DOCUMENT CHANGE REQUEST

DCR number 446	Changes required for: N/A	Originator: Connecteurs Electriques
Date: 2008/11/21	Date sent: 2008/11/21	Organisation: CNES
Status: IMPLEMENTED

Title:	Connectors Miniature Electrical Circular Push-Pull Coupling Removable Crimp Contacts, based on		
Number:	3401/008	Issue:	1

Figure 2 page 8 "Shell type 70 - square flange receptacle"

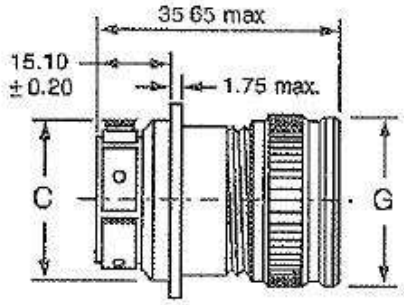
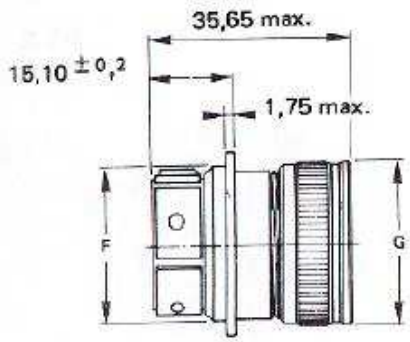
Mistake appears in the specification since it was created.
Cotation 15.10Â±0.20 is not correctly attached. It is attached in front of flange, it must be attached on the rear of flange (see document attached)

Specification to be corrected according to DEUTSCH design unchanged since DBAS connector qualification.
